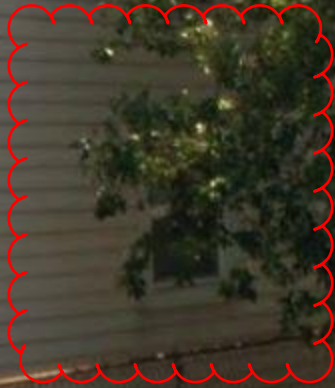
Replace kitchen window with new 6/6 wood window. Header height to match other windows on elevation

WINDOW DETAIL

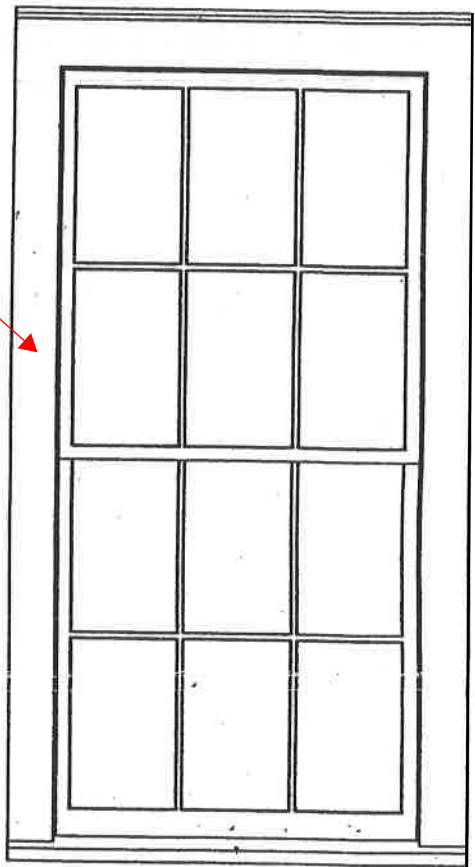
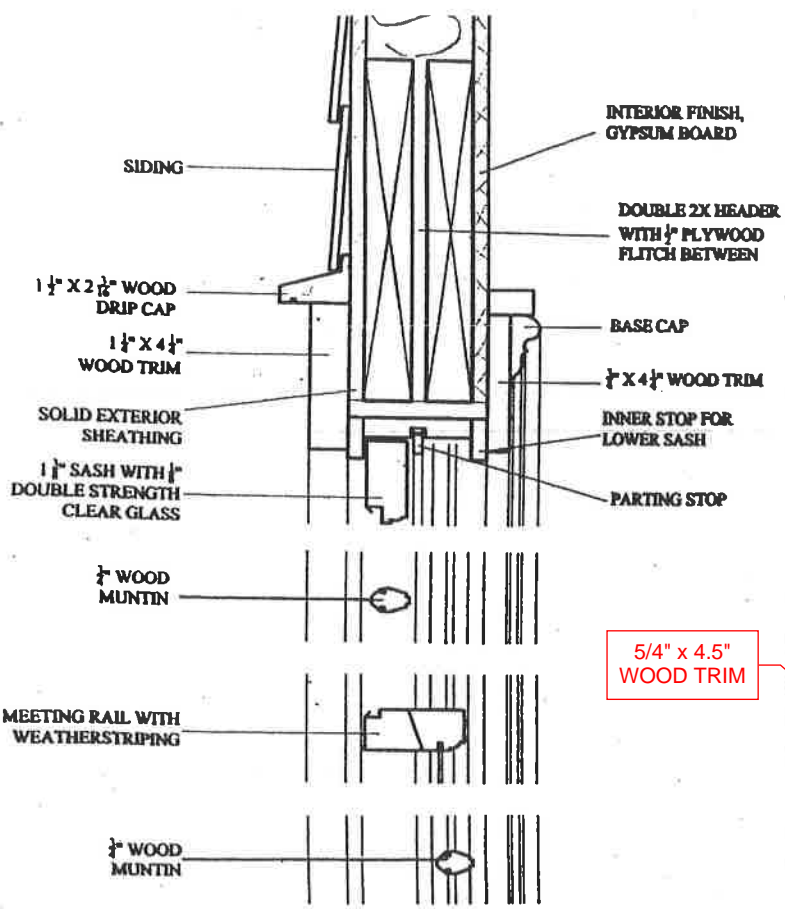
Glass in new window to be clear, non-tinted and non-textured.

WINDOWS MUST BE RECESS MOUNTED INTO THE OPENING

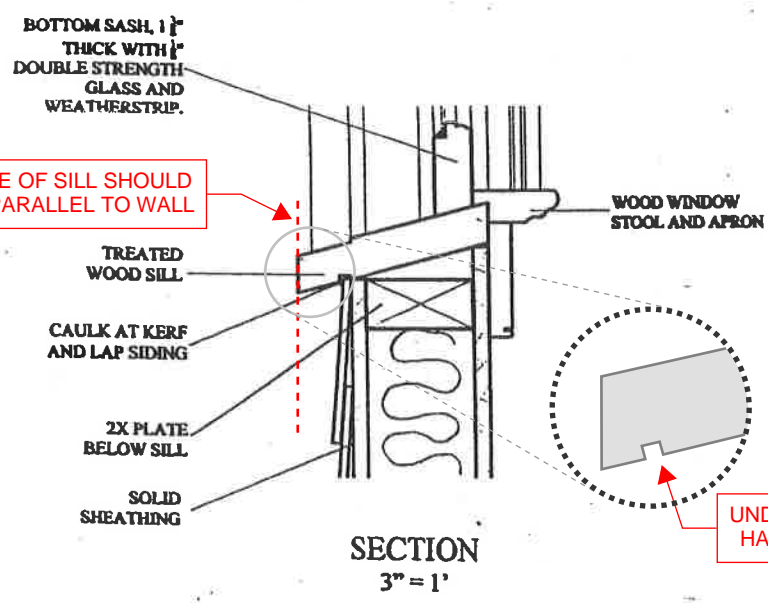
FACE OF SILL SHOULD BE PARALLEL TO WALL

UNDERSIDE OF SILL SHOULD HAVE A ROUTED DRIP LINE
